SR 141/Bethelview Road @ SR 9 (Atlanta Highway) Intersection Improvements

CSSTP-0007-00(999), P.I. No. 0007999
Forsyth County, Georgia

Value Engineering Study Report

September 2009

ALT. No.
P-3/ROW-2
Sht. 2 of 5

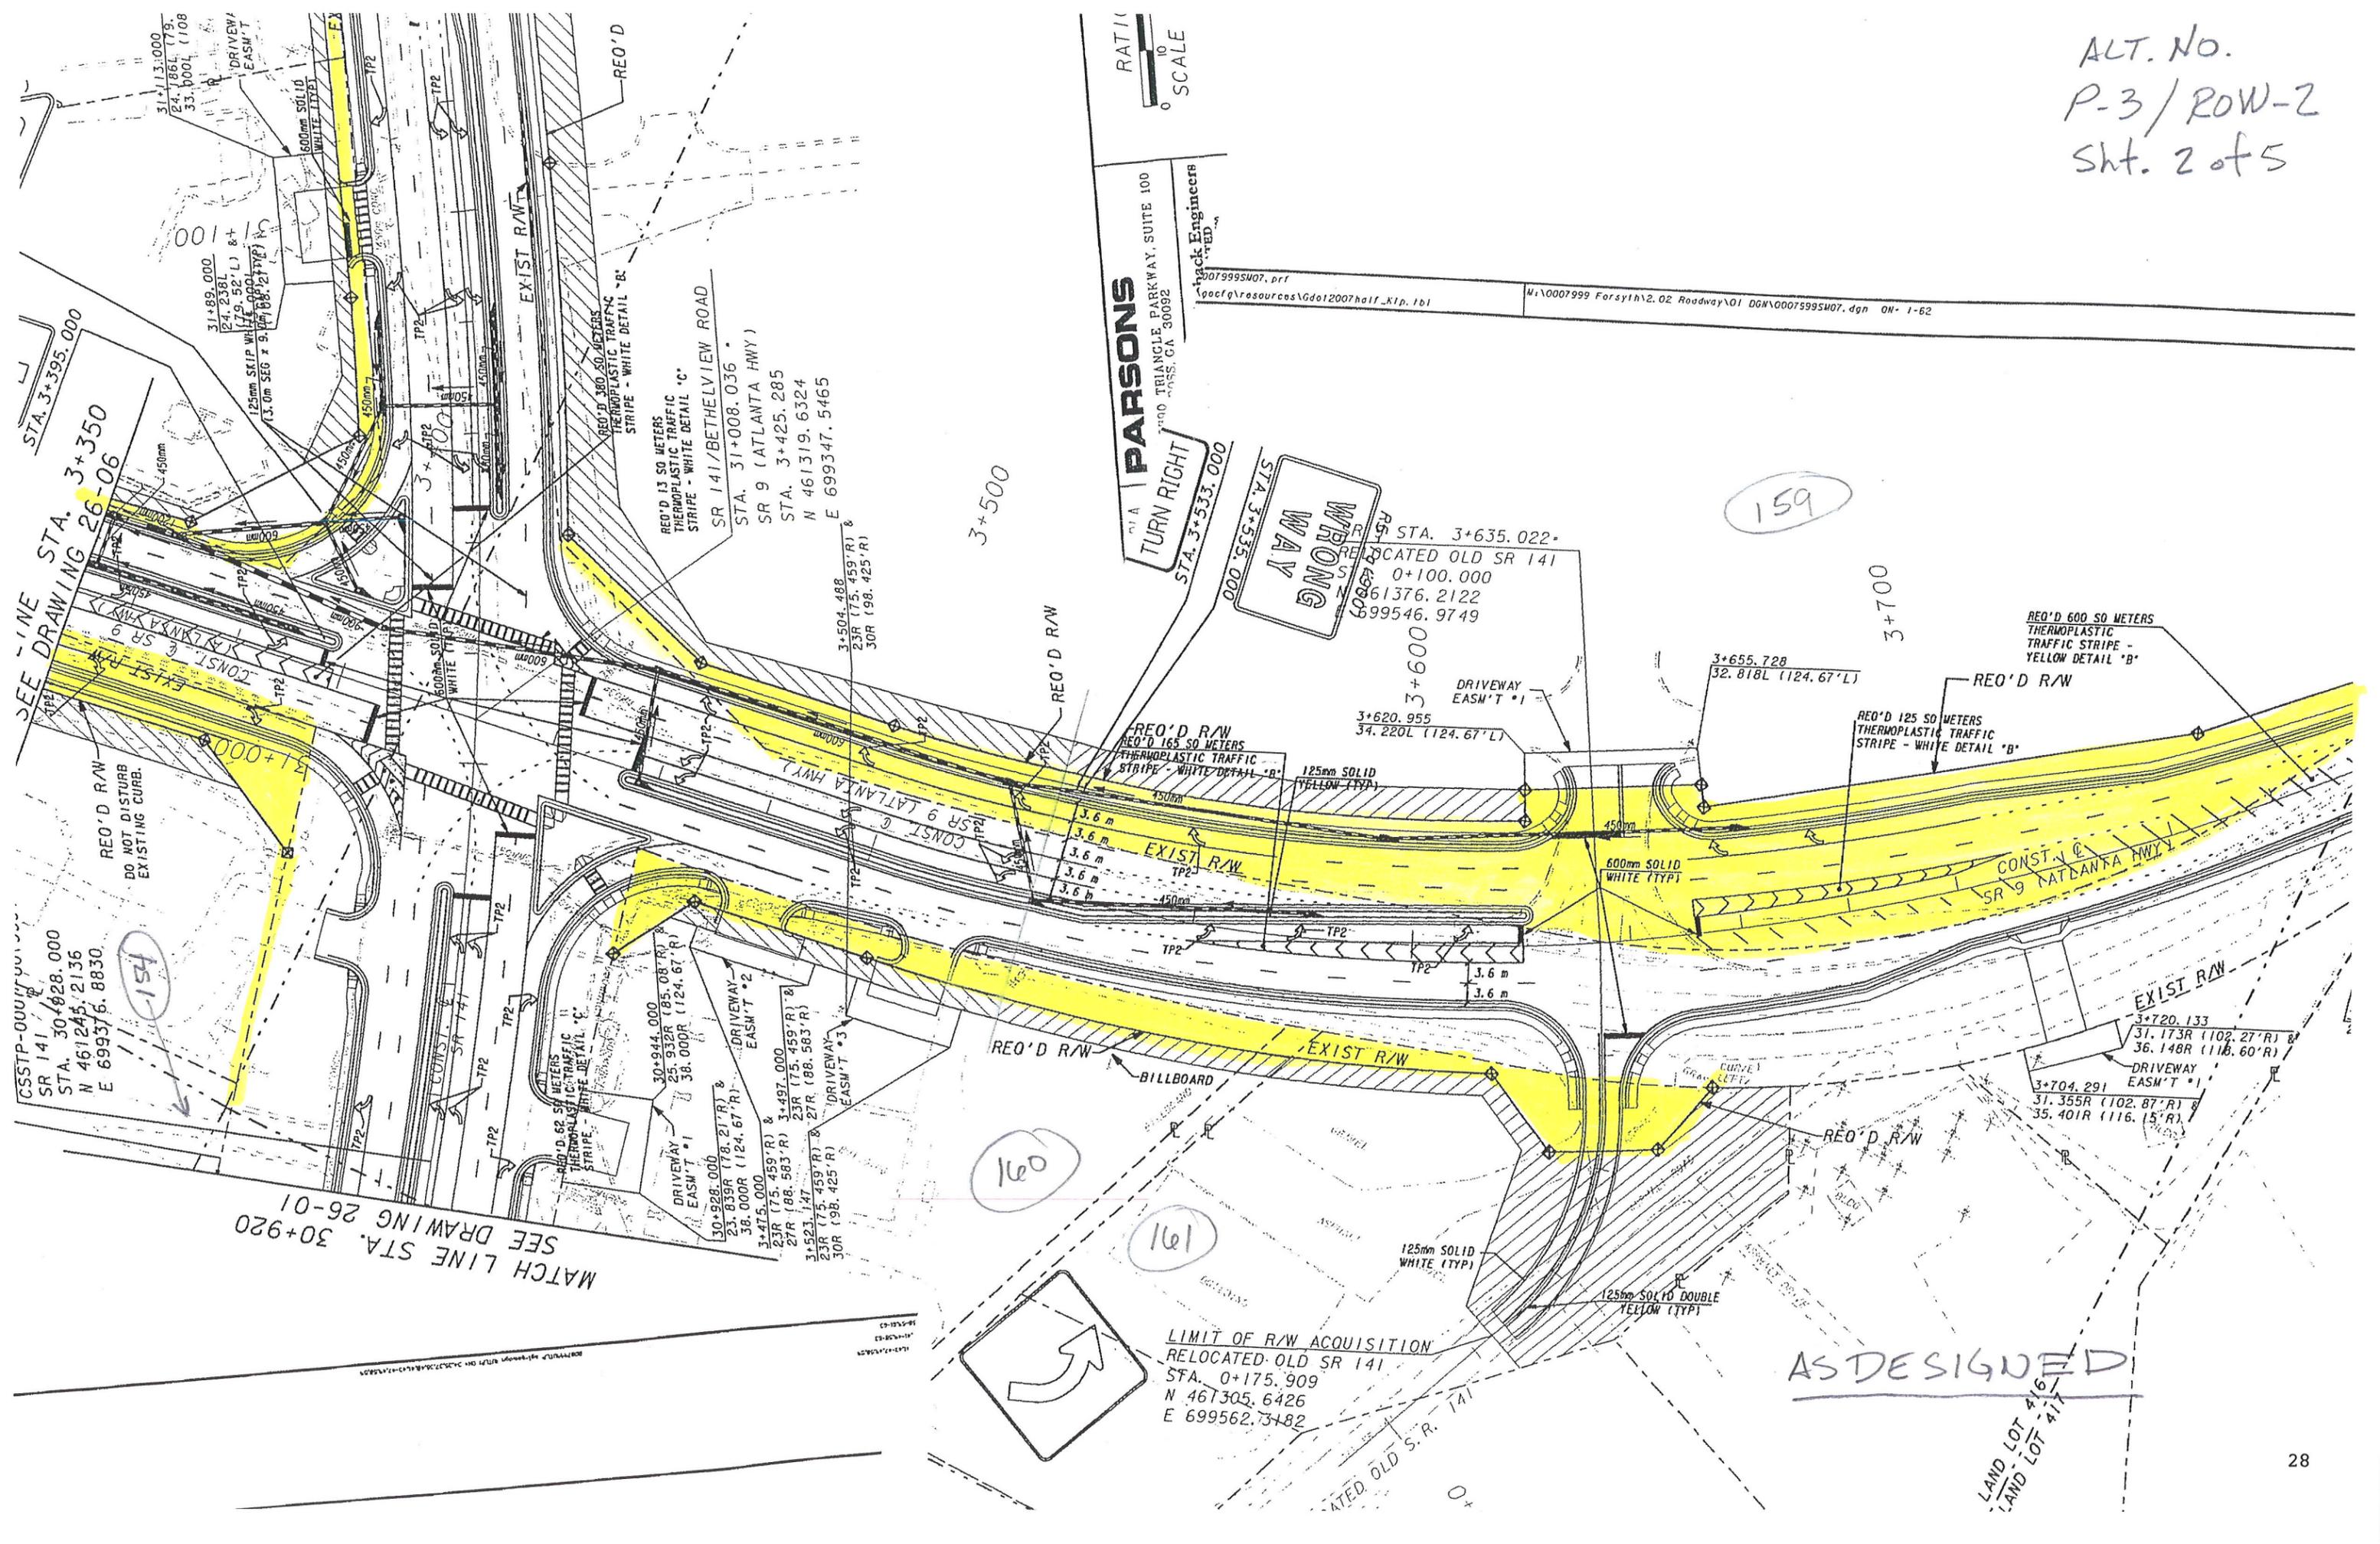
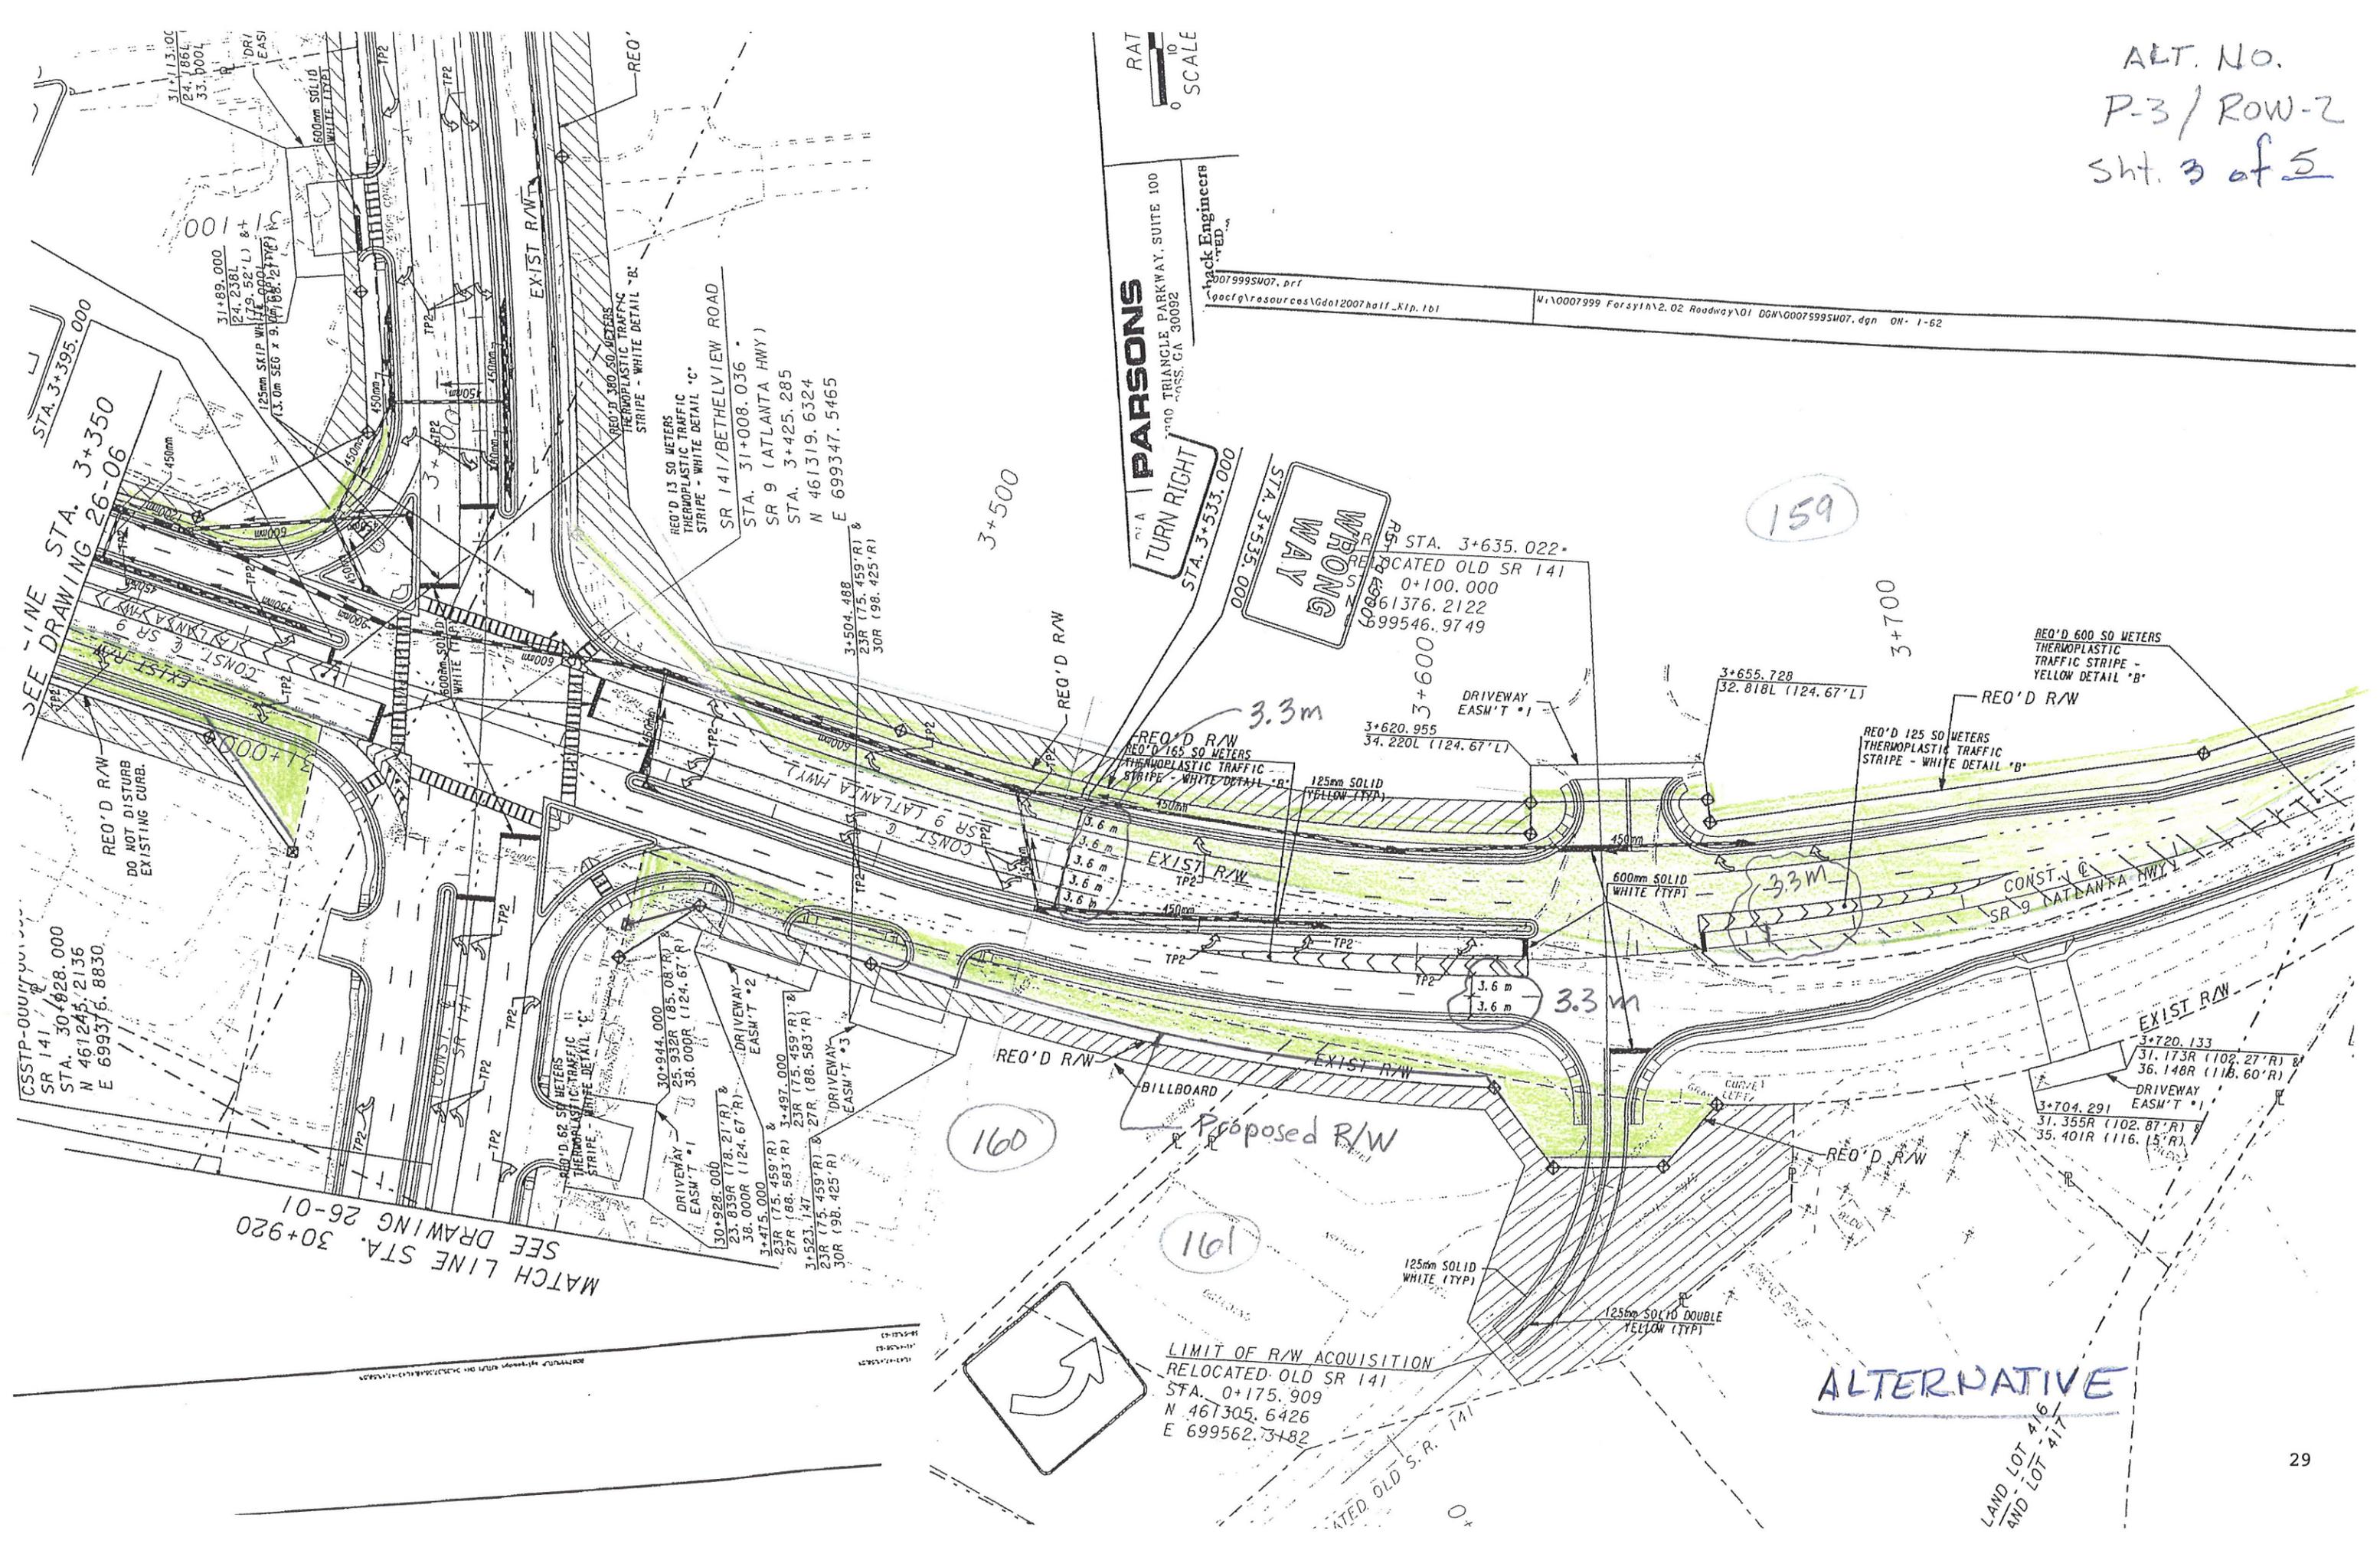
Narrow all of the lanes to 3.3-meters-wide to match the lane widths on the west side of the intersection from Sta. 3+425 to Sta. 3+863. Hold the north right-of-way line along Parcel #159 and move the right-of-way line north along Parcel #160. Revise the new right-of-way line at the corner of the parcel to minimize the impact to the water retention pond.
